Date: 2012-11-23

Engineering Change Request – Class I

New BPMs nearby BGI in IP 4

Figure 1: Photographs of proposed locations of BPMs: cells C5L4 and C5R4, between BGIs and D3 magnet, face to BSRT. (Courtesy of Thibaut Lefevre.)

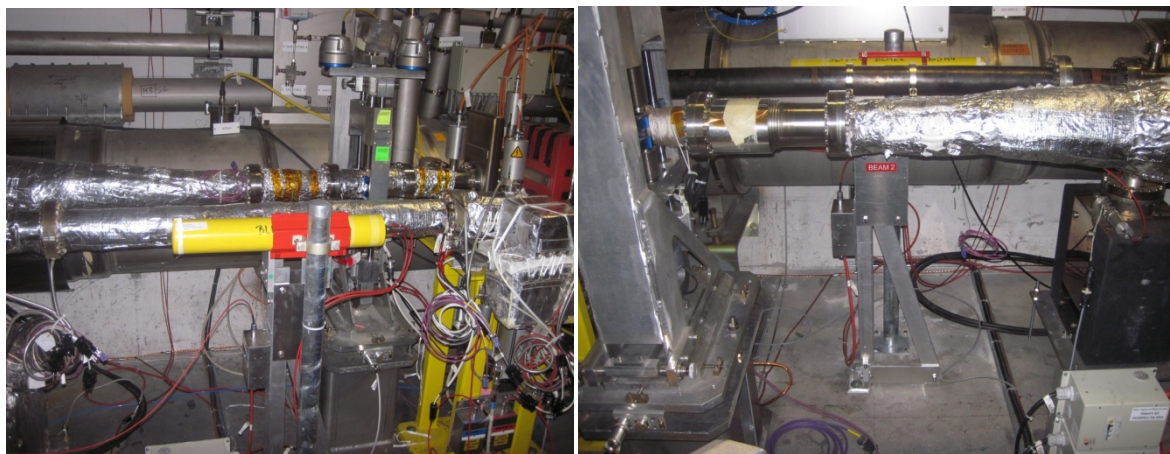
The present situation in the proposed locations of the two new BPMs in cells C5L4 (for beam 1) and C5R4 (for beam 2) are shown on photographs in Figure 1 and on drawings in Figure 2. The vacuum chambers currently installed in these places (VCDEC of 1235 mm and VCDDS of 200 mm) should be replaced with a shorter chambers (VCDFR and VMAAA are proposed), a BPMWI (an enlarged button BPM with an aperture of 80 mm) and its associated bellows.

Figure 3: The proposed modification of the vacuum sectors in C5L4 (beam 1, upper drawing) and C5R4 (beam 2, bottom drawing). (Courtesy of JP Corso).

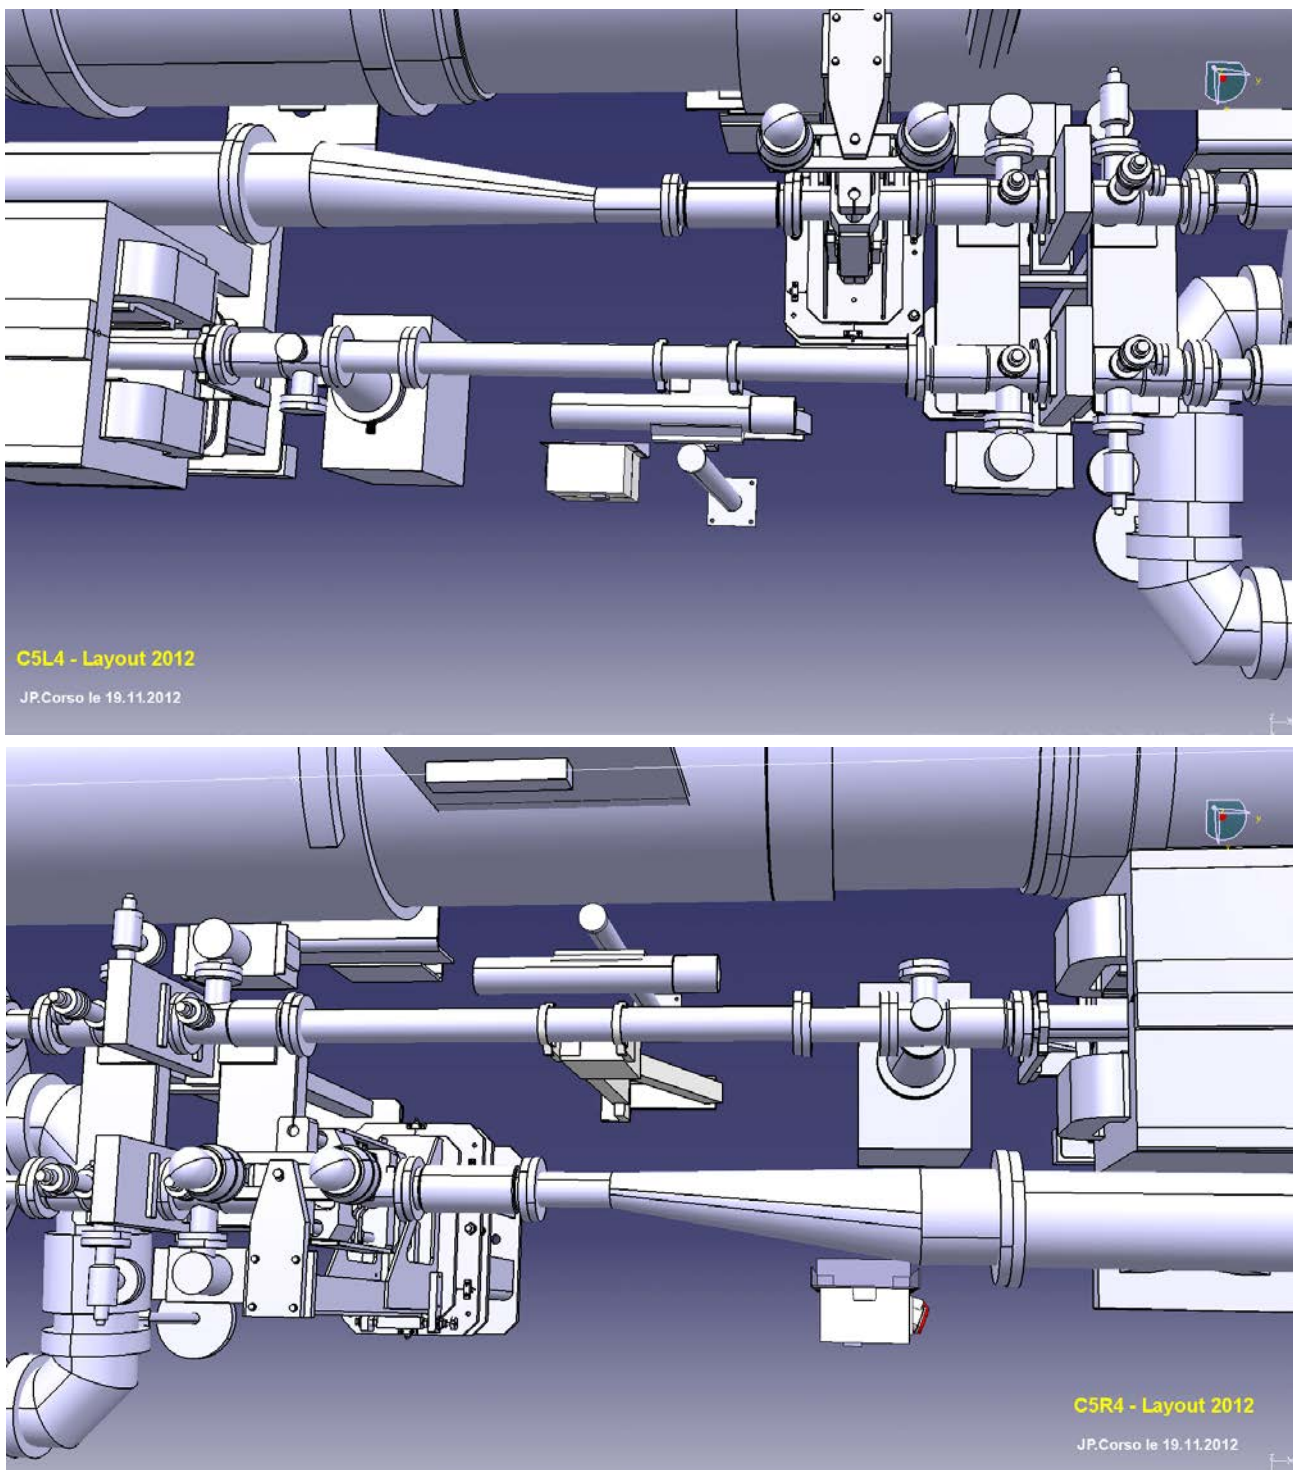
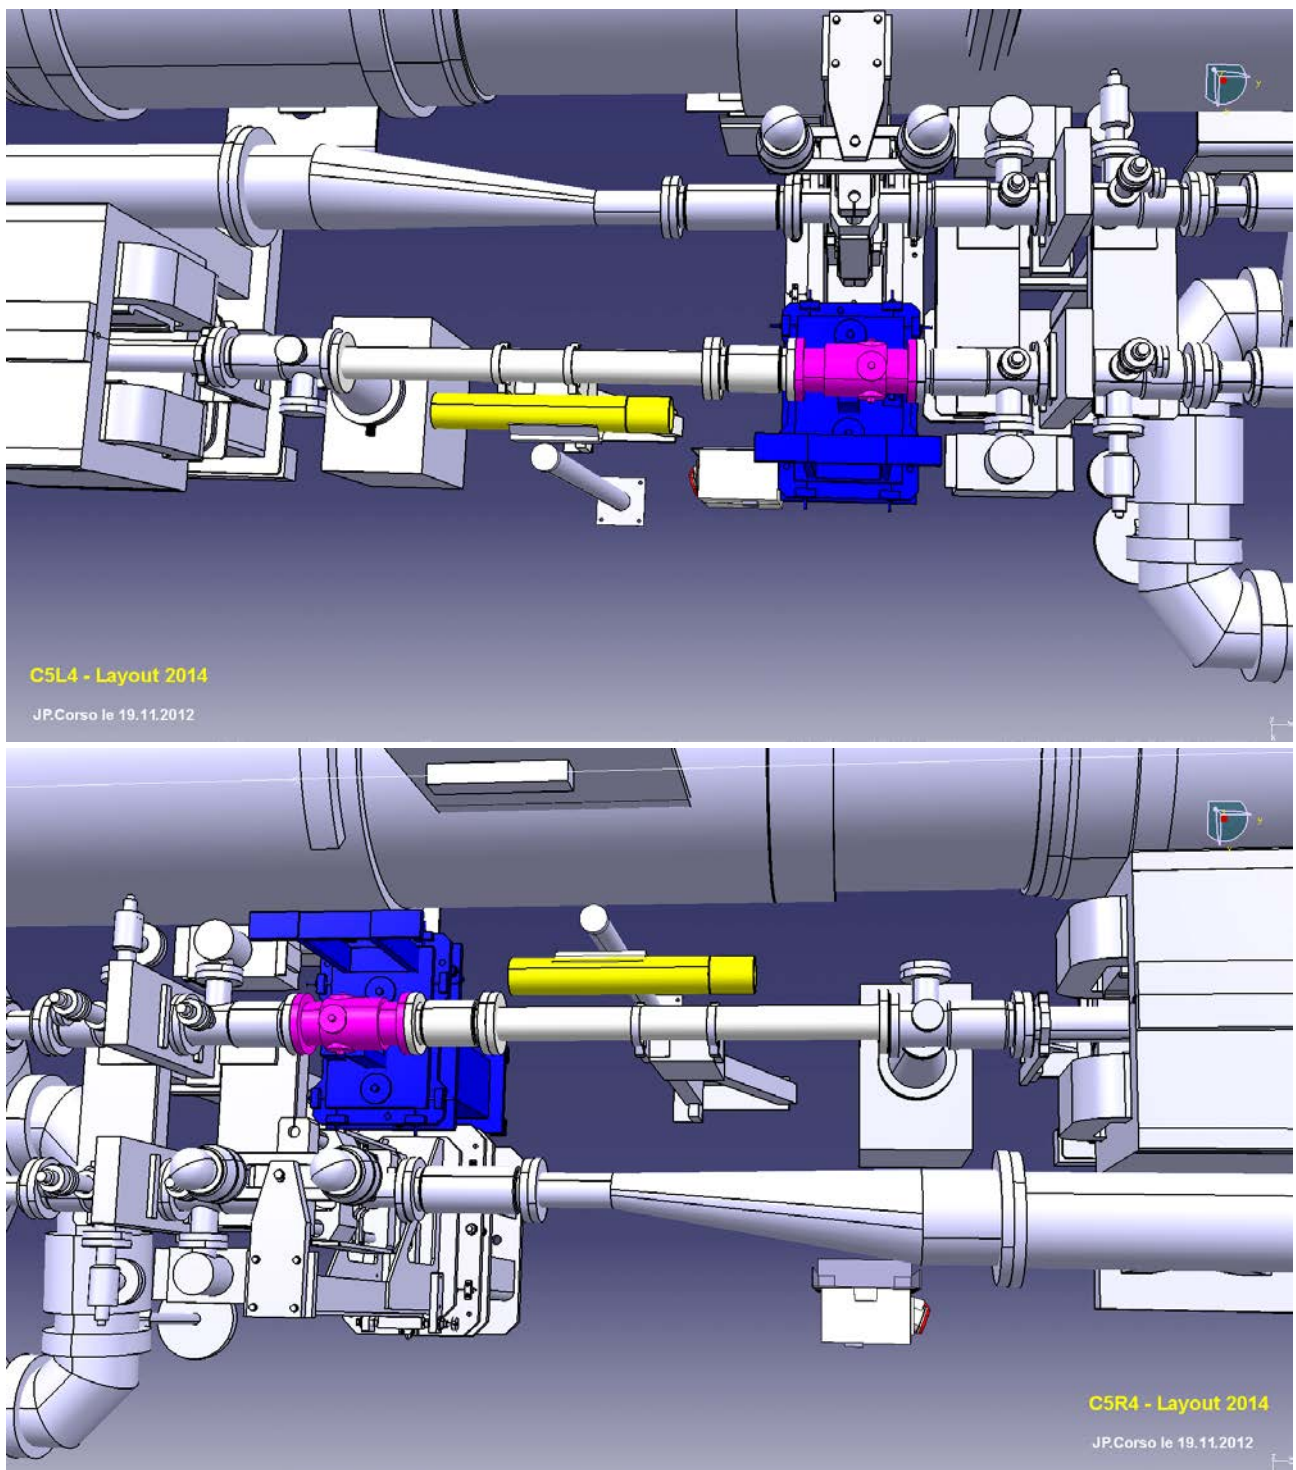
The proposed new layouts of the vacuum sectors after BPM integration are shown on drawings in Figure 3. The names and lengths of the present and proposed vacuum elements are detailed in Tables 1 and 2.

LENGTH	S START	S END	NAME	BEAM	FAMILY	NOTE
0.300	9936.7152	9937.015 2	VAMFQ.5L4.B	I	B	-, -, VPIC
0.945	9937.0152	9937.960 2	VCDFR	I	B	NEW
0.205	9937.9602	9938.165 2	VMAAA	I	B	NEW
0.285	9938.1652	9938.450 2	BPMWI.5L4.B1	I	B	NEW
0.665	9938.4502	9939.115 2	VAHHA.5L4.C	IE	C	VPIA, VGP :: VVFM, VVRD, VGP

LENGTH	S START	S END	NAME	BEAM	FAMILY	NOTE
0.665	10055.047	10055.712	VAHHA.5R4.C	IE	C	VVFM, VVRD, VGP :: VPIA, VGP
0.285	10055.712	10055.997	BPMWI.5R4.B2	E	R	NEW

0.205	10055.997	10056.202	VMAAA	E	R	NEW
0.945	10056.202	10057.147	VCDFR	E	R	NEW
0.3	10057.147	10057.447	VAMFQ.5R4.R	E	R	-, -, VPIC
